Engineering Change Notification

This notice is to inform you of a change to the following product(s):

Old Thickness	New Thickness
 <p>Overall: 5.08±0.4 TFT: 3.50±0.3 CTP: 1.40±0.1 0.18(Adhesive)</p>	 <p>Overall: 5.20±0.4 TFT: 3.50±0.3 CTP: 1.40±0.1 0.3 (Adhesive)</p>

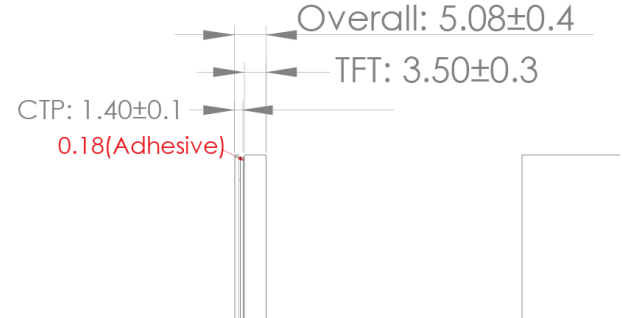
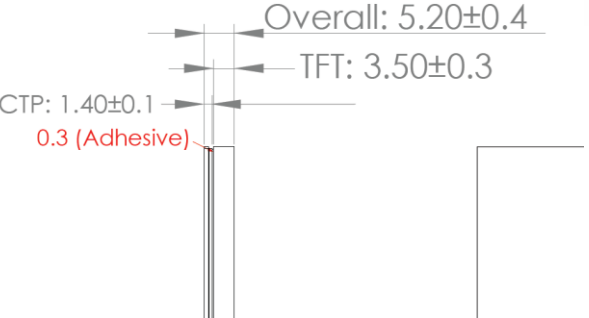
The perimeter bond thickness between the touch panel and display has also increased from 0.18mm to 0.3mm. This brings the touch panels overall thickness from 5.08mm to 5.20mm ±0.4mm
